1431 NORTHERN COURT  
MADISON, WI 53703  
P 608.251.1814

RE: Landmarks Commission meeting March 25, 2019  
University Heights Historic District  
Debra Shapiro and Mark Beatty  
2122 Kendall Ave., Madison, WI 53726  
**ADDENDUM to Original Narrative dated 3/1/19**

1 FRONT ELEVATION  
3 SCALE: 1/4" = 1'-0"

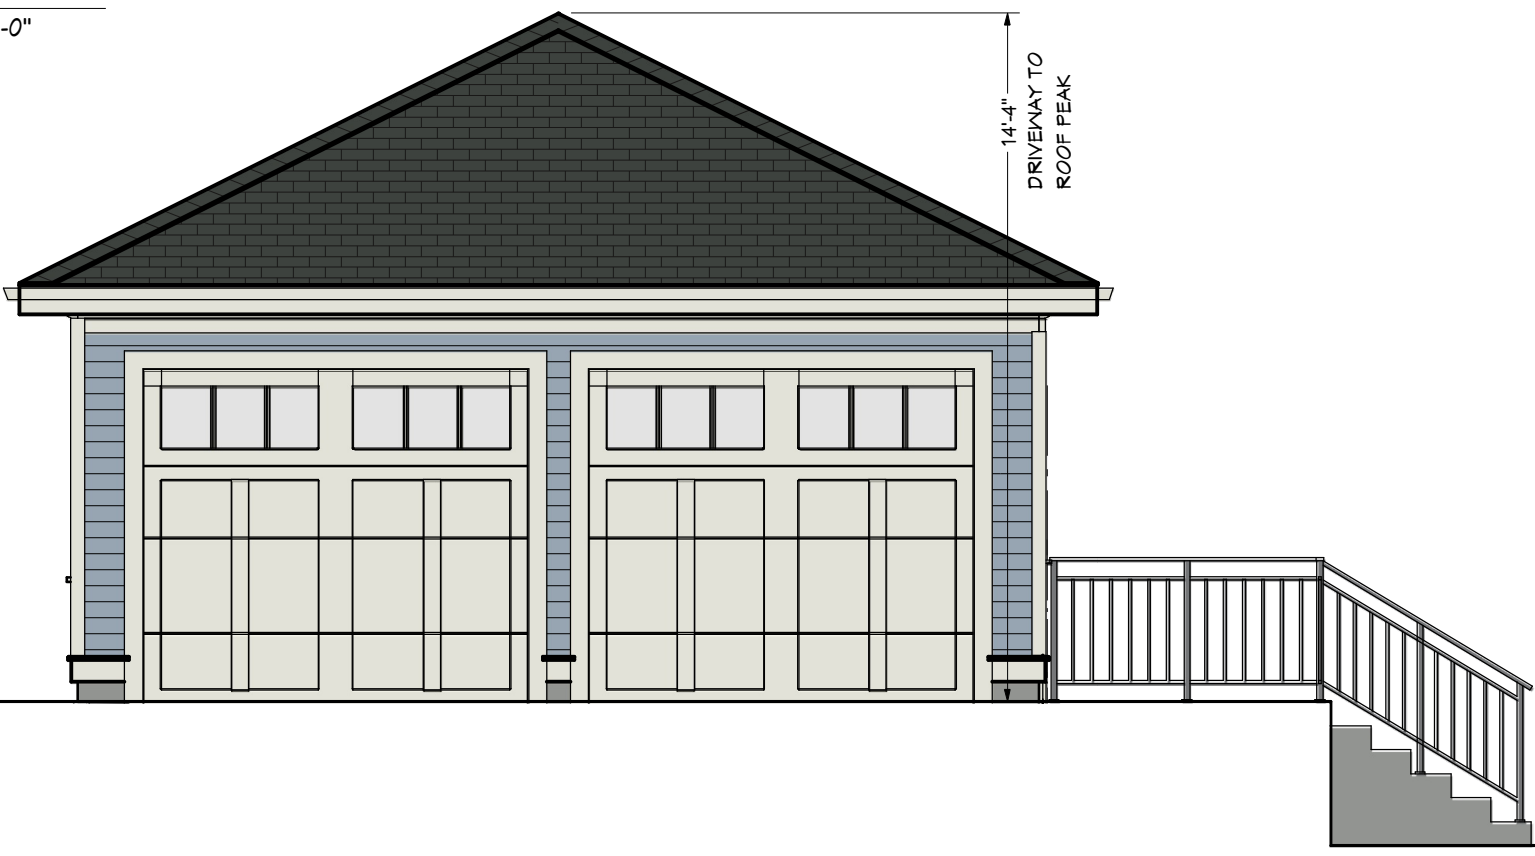
*In the ordinance, Section 41.24(4)(b) states: "Accessory Structures. Accessory structures, as defined in Section 28.211, MGO, shall be compatible with the design of the existing structures on the zoning lot, shall not exceed fifteen (15) feet in height and shall be as unobtrusive as possible. No accessory structure shall be erected in any yard except a rear yard. Exterior wall materials shall be the same as those for construction of new principal structures as set forth in Sec. 41.24(4)(a)2."* Yes, we have outlined the exterior materials in the narrative and updated the planset to reflect material changes. The new structure is compliant with the zoning setback requirements as it relates to the specific criteria that addresses existing/replaced accessory structures. In the revised planset you'll see that the height from the driveway is 14'4" to the peak.

14'-4"  
DRIVEWAY TO  
ROOF PEAK
